APPEAL SUMMARY

Appeal ID: 20249

Project Address: 3424 SE 13th Ave

Appeal Type: Plumbing

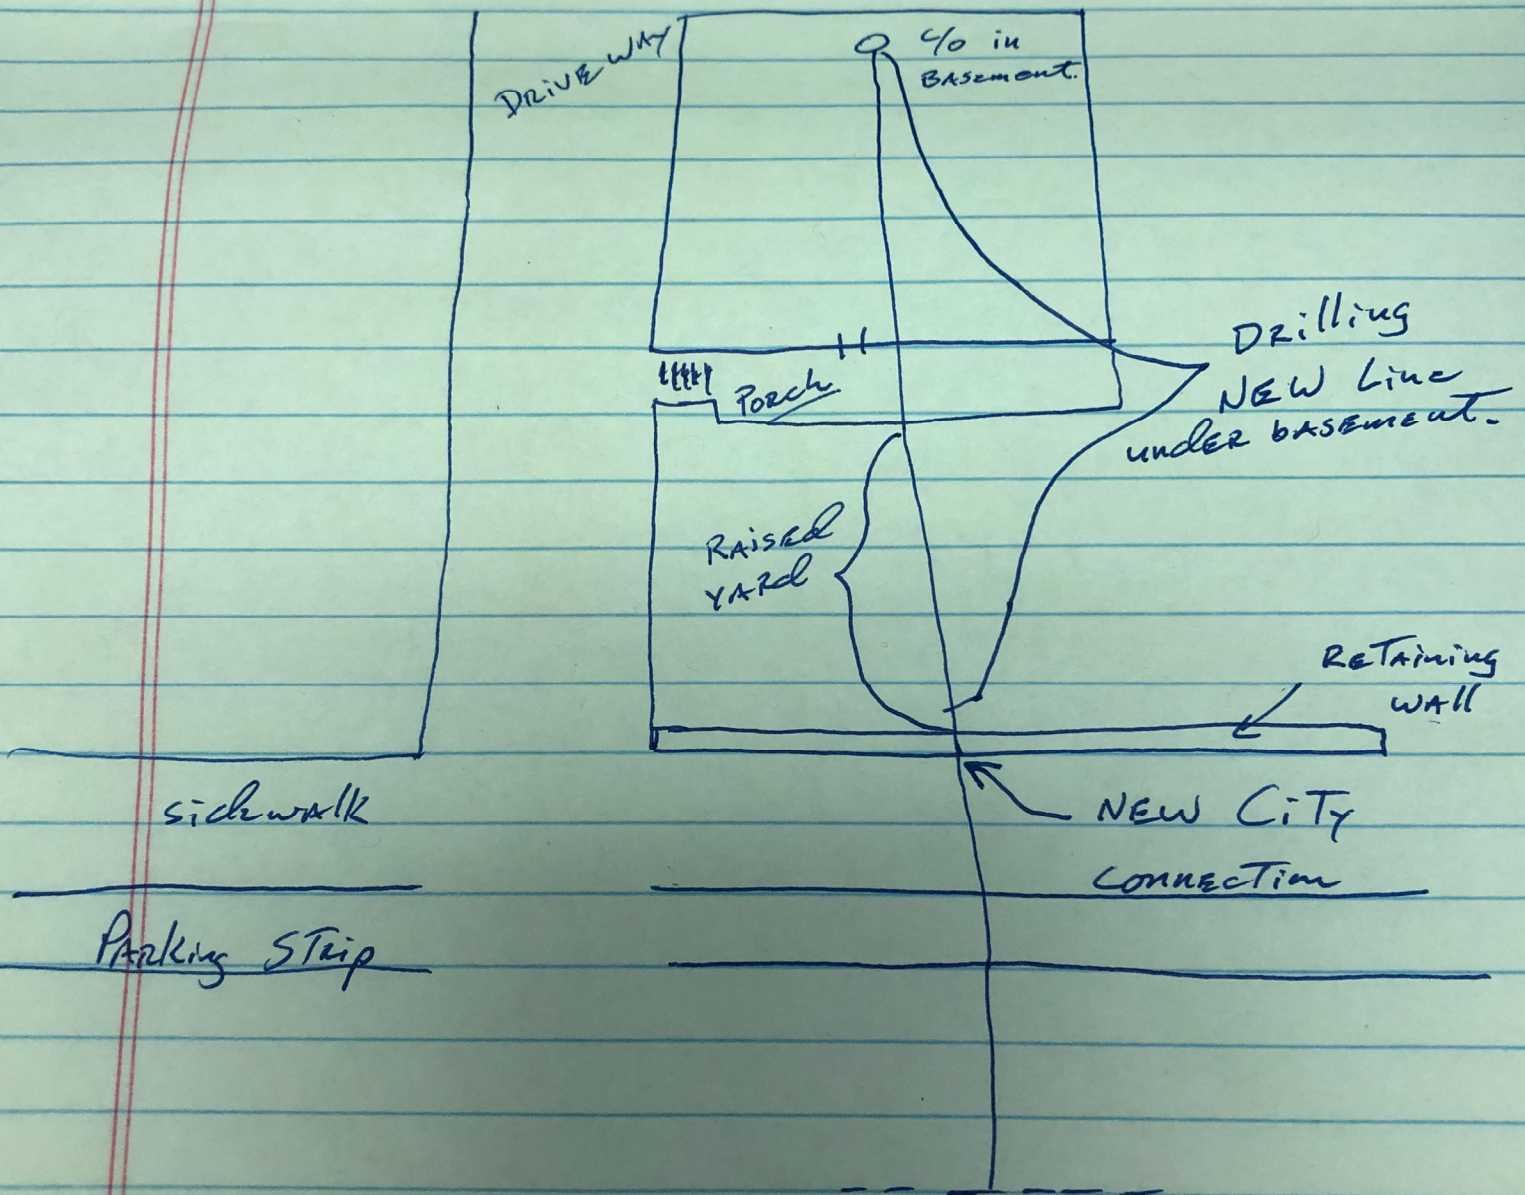
Requires Using HDPE in lieu of ABS pipe under foundation.

Proposed Design Replacing existing line under basement floor with HDPE via drilling.

See attached drawing. .

Reason for alternative Homeowner wants to upgrade system to accommodate future fixtures when remodeling basement. New extension in street requiring hookup so doing all now. Will save demolition in basement.

Use of HDPE in lieu of ABS pipe under foundation: No decision rendered. Refer to Code Guide for Sanitary Sewer Pipe Materials online at <https://www.portlandoregon.gov/bds/article/468070>
